AMENDMENT OF SOLICITATION/MODIFICATION OF CONTRACT			1. Contract Number DCKA-2007-B-0143	Page of Pages 1 18
2. Amendment/Modification Number 3	3. Effective Date 8/19/2008	4. Requisition/Purchase Request No.	5. Solicitation Caption Repair and Repainting of Chain Bridge

AMENDMENT NO. 3 **ISSUED** **August 19, 2008** **6 Page(s)**
DCKA-2007-B-0143

**REPAIR AND REPAINTING OF CHAIN BRIDGE
OVER POTOMAC RIVER AND C&O CANAL (BRIDGE NO. 1)
F.A.P. No.: BH-1102(26)**

EXISTING STRUCTURAL GROUND DETAIL
(2 GROUND LOCATIONS @ DC ABUTMENT)
N.T.S.
REPLACE STRUCTURAL GROUND ON NORTHSIDE OF ABUTMENT INCLUDED IN 621 991 MISC. ELECTRICAL WORK

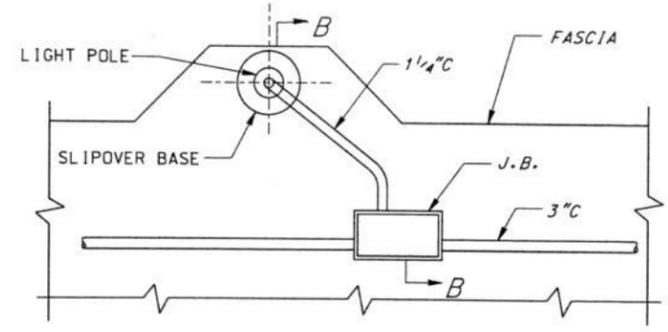
QUESTION: Does the grounding conduit at the North abutment need to be PVC coated rigid conduit?

RESPONSE: The grounding conduit shall be PVC coated rigid conduit.

TYPICAL LIGHTING INSTALLATION
SOUTH SIDE
SCALE: 3/4"=1'-0"

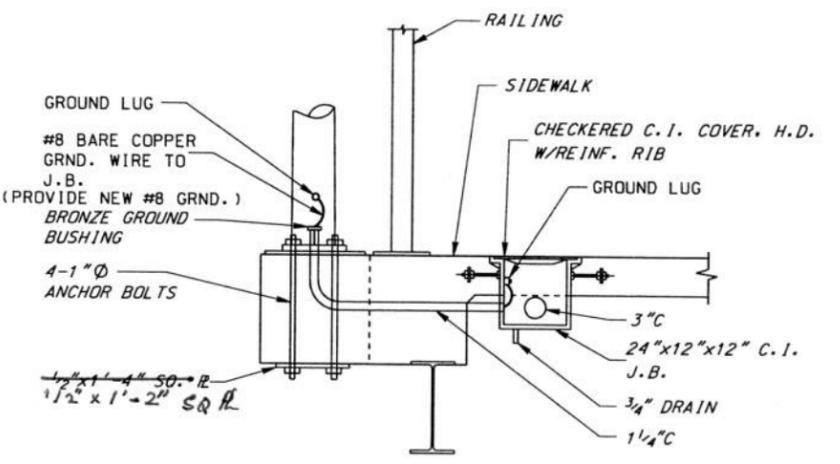
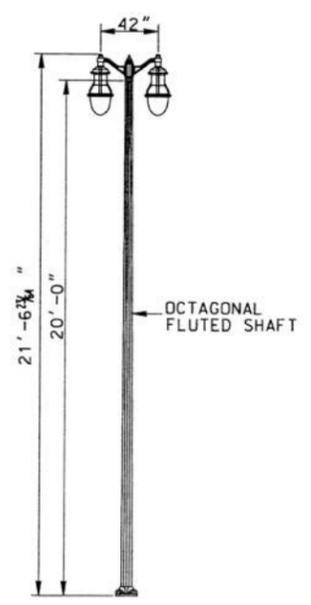
QUESTION: The detail on Sheet 25 (of 55) “Anchor Bolt Replacement at Light Standard” indicates a size of ½” x 14” x 14”. The detail on Sheet 51 (of 55) shows a plate sized ½” x 16” x 16”. Which is correct?

REPLACE: call out “1/2” x 1’-4” SQ. PL” as shown in “ TYPICAL LIGHTING
INSTALLATION” and “ SECTION B-B” on Contract Drawing sheet 51 of 55 with “ 1/2” x 1’-2”
SQ. PL”.

RESPONSE: The correct plate size is ½” x 14” x 14” as per the existing drawings.

20 FOOT ALUMINUM BRIDGE POLE WITH INTERNAL DAMPER

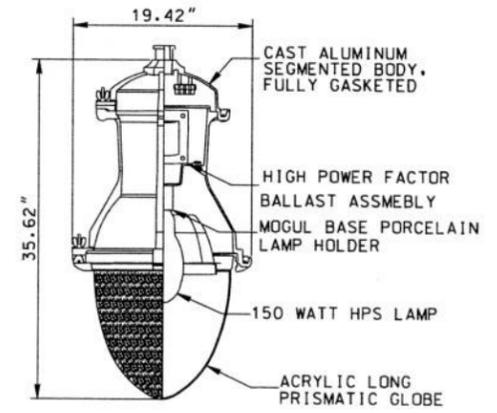
QUESTION: The light pole anchoring details indicate the new light poles having an internal grounding lug. The detail of the new pole does not indicate an access door to achieve the grounding. Clarify?

RESPONSE: The proposed standard bridge pole has an access door near the base of the pole. The contractor shall submit catalog cuts of the proposed pole for approval. The manufacture’s catalog cuts will indicate an access door.
